Frazier 27 State Com #202H
Lea County, New Mexico

Revised Wellbore Design A
11/11/2020

EOG RESOURCES, INC.
FRAZIER 27 STATE COM #202H

Revised Permit Information 11/11/2020:

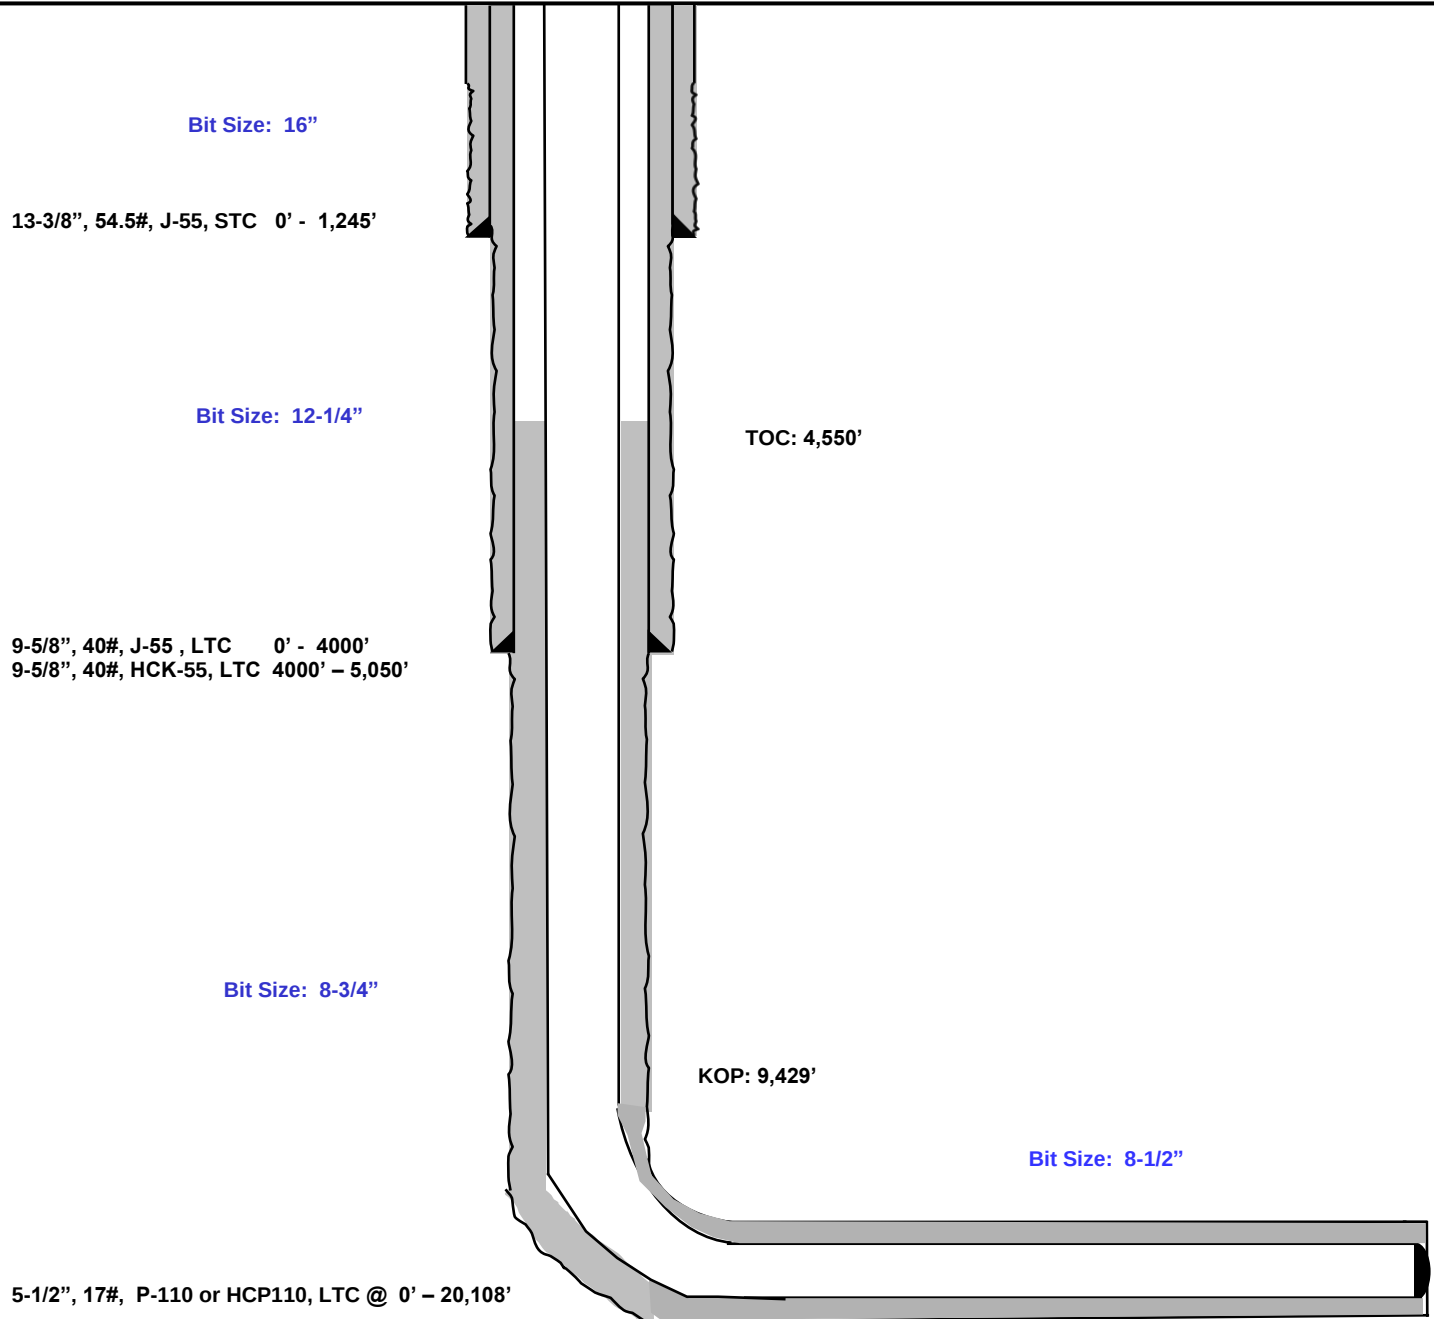
EOG respectfully requests an amendment to our approved APD for this well to reflect the following changes:
Change surface hole size to 16"
Retain previously permitted program as alternate design

EOG respectfully requests to retain the option to drill the previously approved 3 string design, to be referred to in subsequent reports as Design B.
